ROMULUS CITY COUNCIL

Monday, February 27, 2023

Subject: Fairways at Gateway
PDA Amendment Review #7
Application No. PDA-2020-001
Plan Revision Date: November 28, 2022
OHM Project Number: 0155-20-1161

To: Carol Maise, City Planner, City of Romulus
From: Brad Strader, AICP, PTP, Principal
James Goff, PLA, LEED AP ND, Landscape Architect
Date: February 23, 2023
Subj: Review of the revised Fairways at Gateway PDA Amendment/Preliminary PDA Plan (dated 11/28/2022)

PRELIMINARY SITE PLAN
(THE FAIRWAYS AT GATEWAY PDA)
"THE BLUFFS AT GATEWAY"

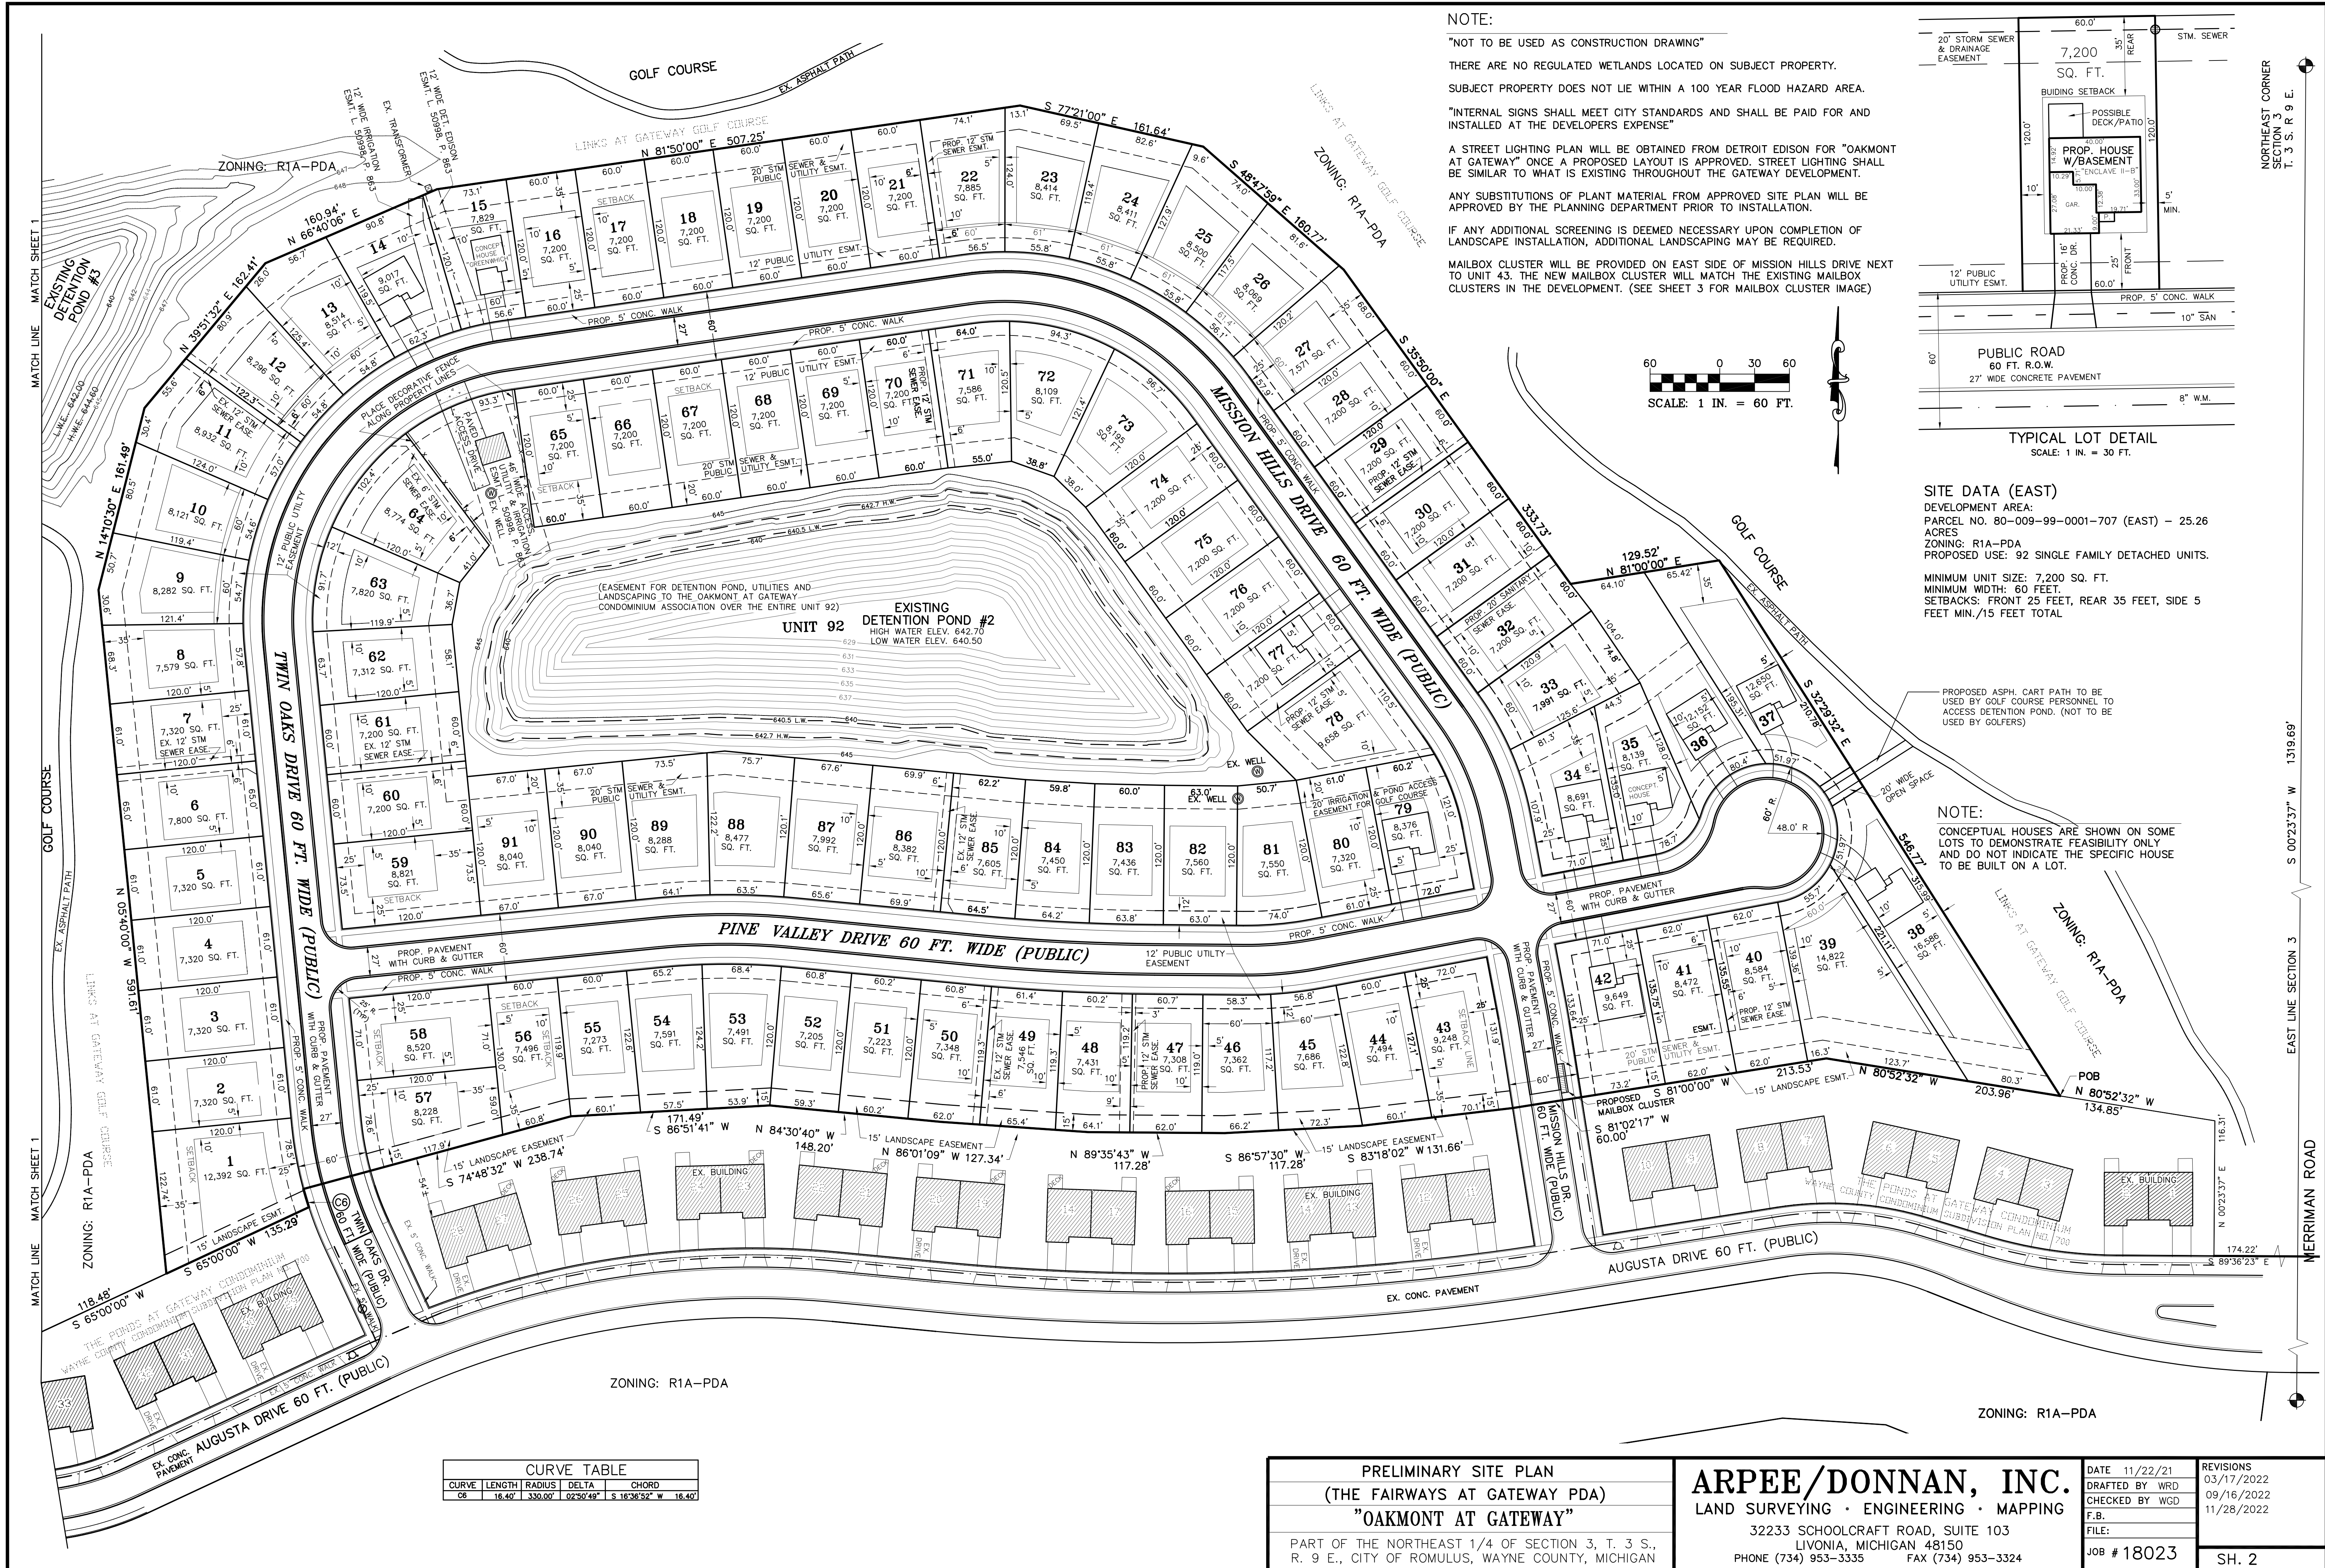
2. **Attached Residential Dimensions:** A request has been noted to deviate from the required 30-foot spacing between the multiple family units, and instead provide a minimum spacing of 20 feet between buildings. Typically, 20 feet is the minimum spacing for a single-family or duplex home, and 30 feet or more is required for more units. But in this case, there is a lot of available open space due to the golf course. *The Planning Commission approved this deviation however it is not referenced in the PDA Agreement. Also note that additional landscaping (evergreen trees) has been added between the units to help provide screening between the units. The PDA Agreement must be revised to acknowledge the approved spacing reduction between the units.*

The drawings also show a “meter room” along the sides of the units. We recommend foundational landscaping be added to screen the front of those meters. The location and screening of the HVACs will need to be shown on the Final Site Plans however a note stating such must be added to a revised Preliminary Plan.

1. Additional plantings around the accessory structures will be shown on the Final Site Plans including foundational landscaping around the meters; a note must be added to the Preliminary Plan stating this;
2. The PDA Agreement must acknowledge the waiver to the spacing requirements between the units (buildings) from 30 feet to 20 feet as approved by the Planning Commission;
3. The proposed golf cart path between units 37 & 38 shown on the Utility and Site plan must also be shown on the Landscape, Signage, and Grading plans; and
4. All revisions dates must be included on the Preliminary Site Plan and associated documents. While included on the revised landscape plans, the complete set of plans should reflect the same date and submitted to the City for approval.

LANDSCAPING PLANTING PLAN scale: 1" = 60'

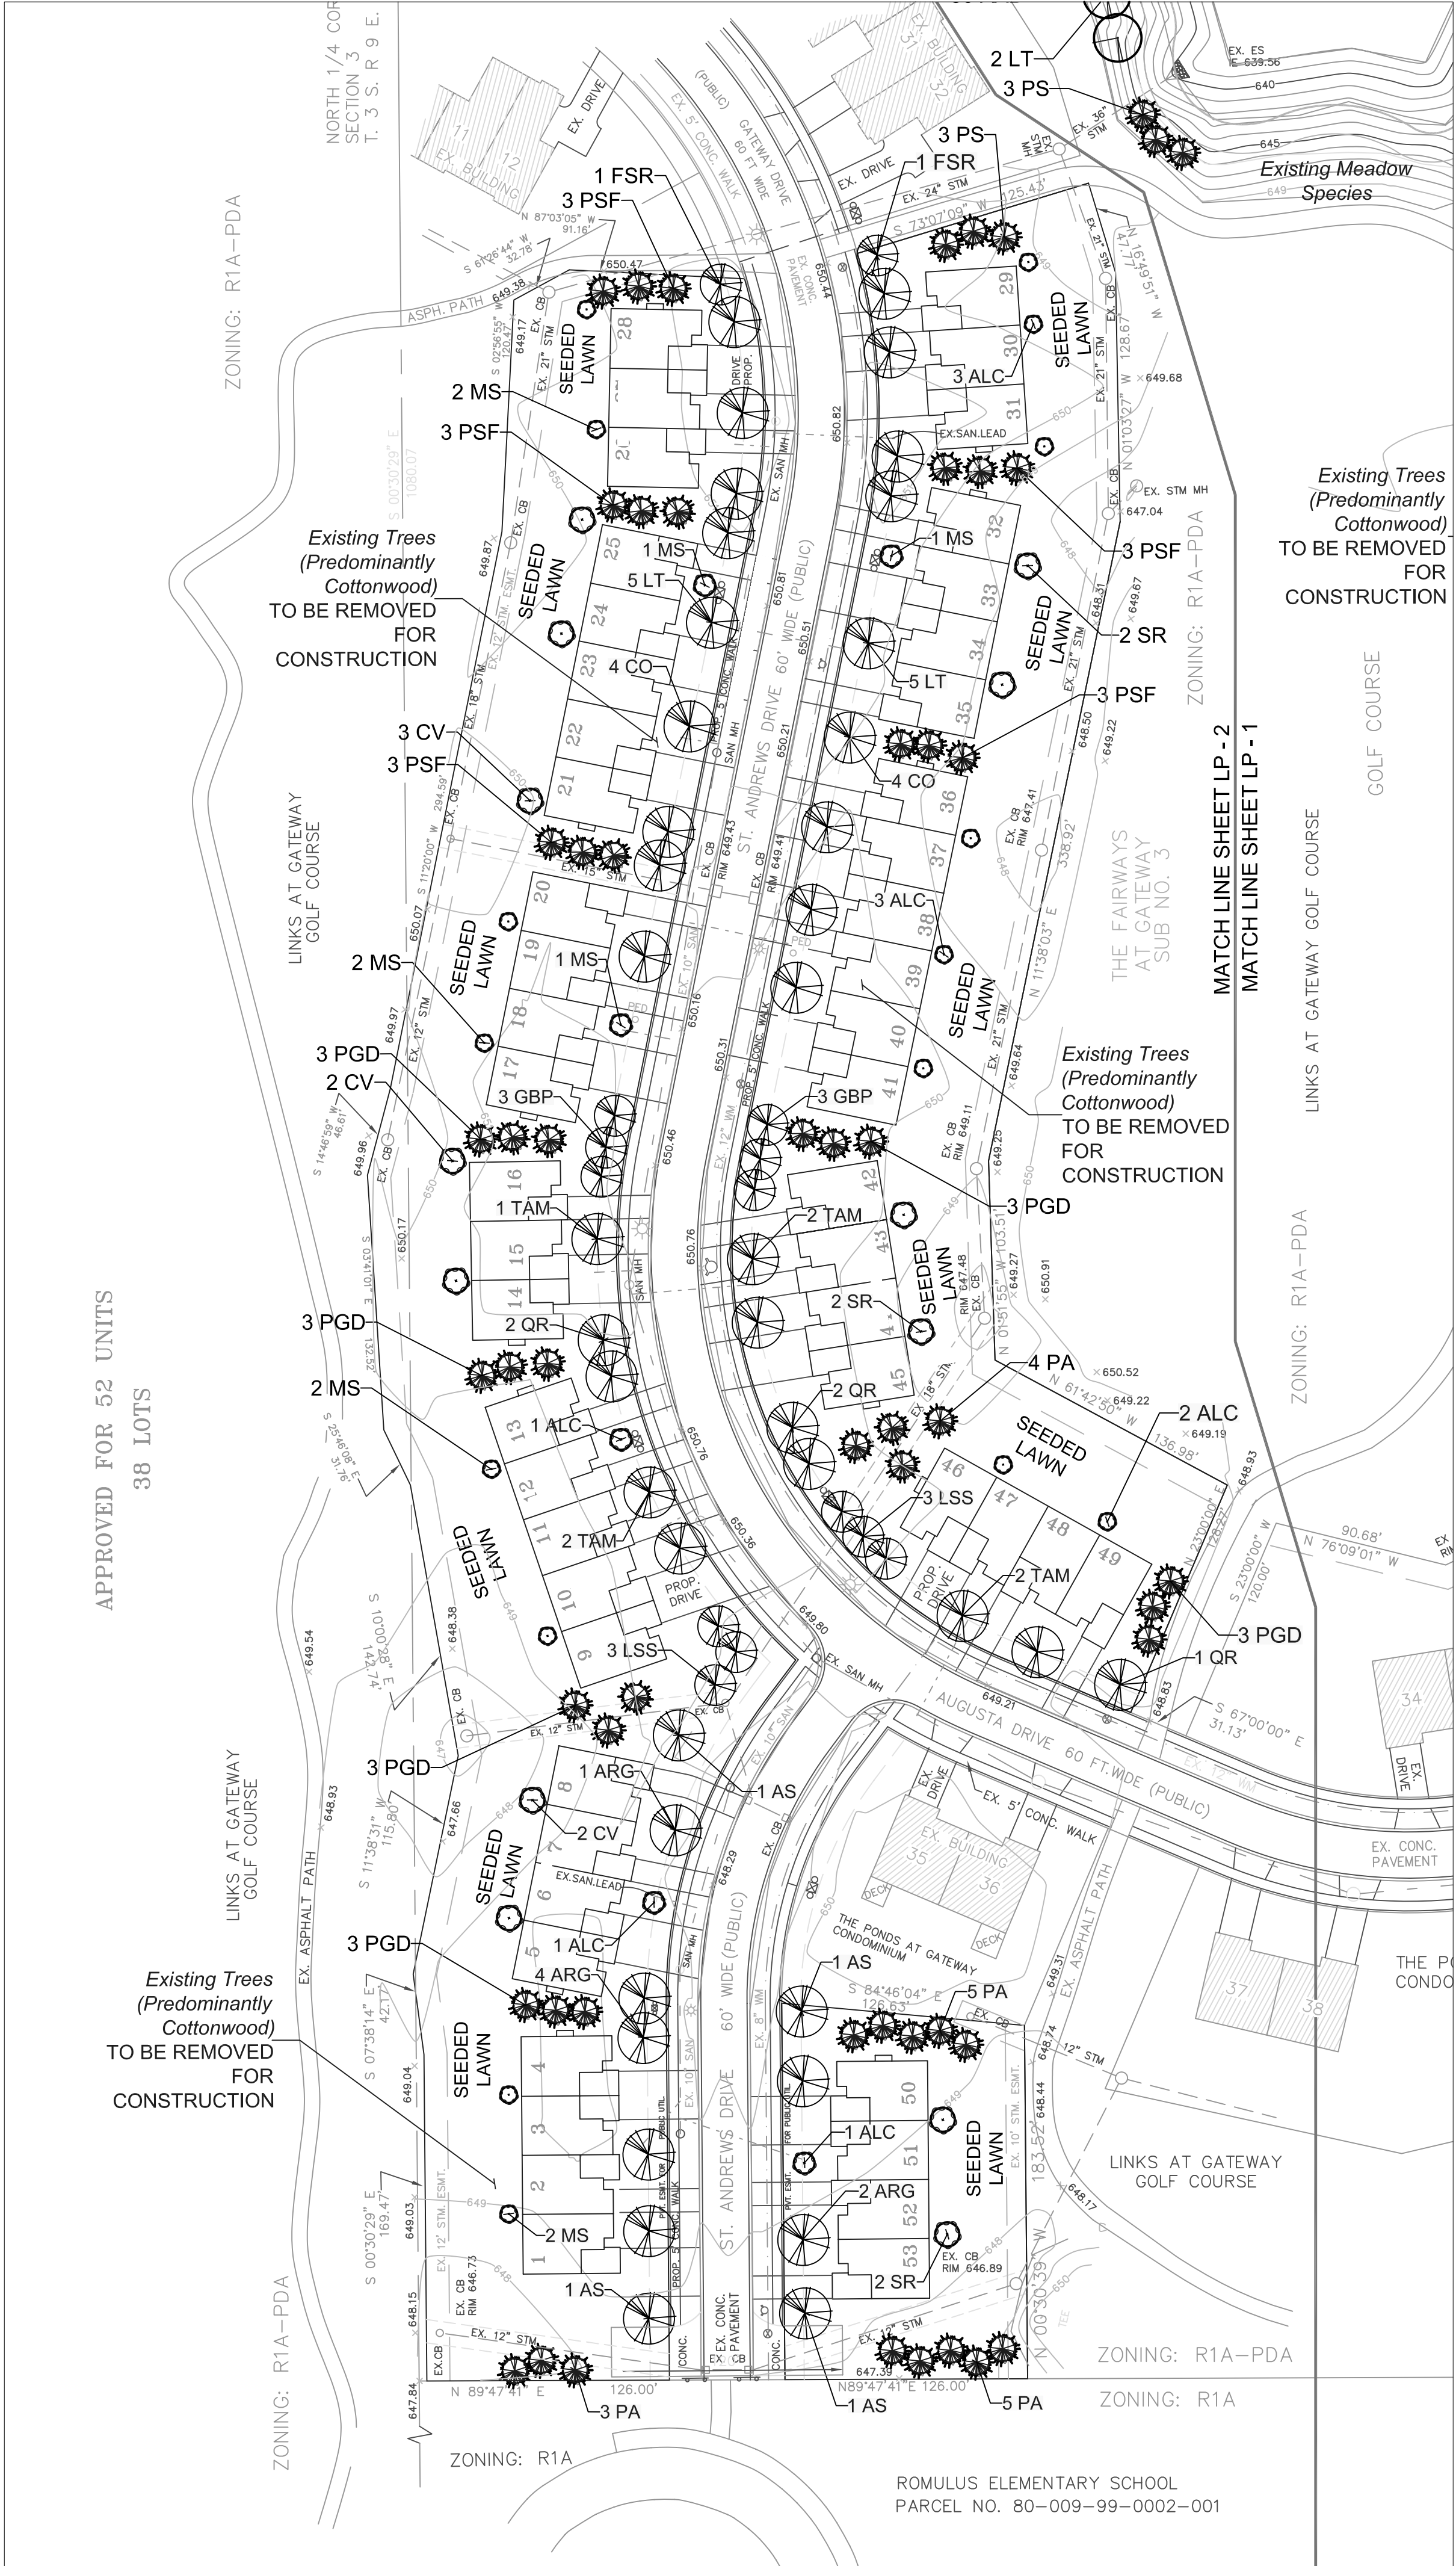
5. **The Bluffs at Gateway (Attached Residential) Landscape Plan:** Previous changes added evergreen trees between the 4/5-plexes to help offset the impact of reducing the separation between buildings from a minimum 30 feet to 20 feet. The landscape plans meet the requirements for residential street trees, and landscaping around accessory structures. As plans move into Final Site Plan drawings, these structures should be screened with recommended plant materials. This must be noted on a revised Preliminary Landscape Plan.

For cluster housing, the ordinance requires two trees per unit. 53 Units * 2 trees per unit = 106 trees required. *88 Trees have been provided. While the 88 trees falls short of the 106 required trees, this area has been enhanced substantially from previous submittals. The applicant has proposed using the 103 trees in the 15 foot side landscape easement in the Oakmont area be applied to meet this requirement. We find this change to provide an overall better landscape plan, with the understanding that some additional landscaping may be needed for some units to help reduce the impact of errant golf balls, as noted in the OHM letter. A note to this effect must be added to the Preliminary Site Plan. This is now noted on sheet LP – 2 Landscape Planting Plan – West sheet under “additional notes.”*
